DELEGATED REPORT

SUBJECT: CONMAT NO. 2 PTY LTD - OPERATIONAL WORKS (ROADWORKS, EARTHWORKS, DRAINAGE, WATER SUPPLY WORKS AND SEWER WORKS) FOR STAGE 1 - DEVELOPMENT PERMIT RAL/23/0009 – LOT 1 ON RP747077 – RAY ROAD & CATER ROAD, MAREEBA - OPW/24/0009

DATE: 26 September 2025

Figure 1: Extract from Sewer Longitudinal Section from Manhole 10/1 to 11/1
[Source: Erscon Drawing C128, Revision C]

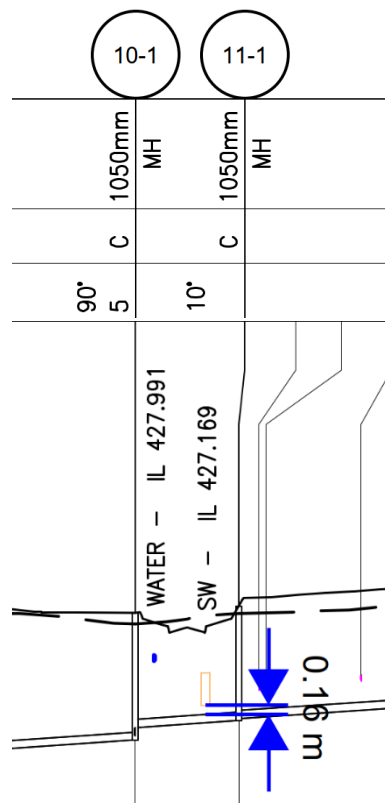
4. The Applicant is required to provide the following information including prior to the Pre-Start Meeting:
- a. Lot control calculations.
 - b. Revised engineering design drawings that increase the vertical clearance between Sewer Line 1 (between sewer manhole 10/1 and 11/1) and the box culvert crossing on Road B in accordance with the Water Services Association of Australia (WSAA) and best engineering practice, unless otherwise agreed with Council in writing.

Advice Note: With reference to the sewer longitudinal section below, Officers' preliminary measurements indicate the vertical clearance between the sewer obvert level and the stormwater box culvert invert level, (approximately 160mm), is less than the minimum clearance permitted by WSAA.

Compliance with the vertical clearance required by WSAA must take into account the thickness of the base slab below the stormwater box culvert.
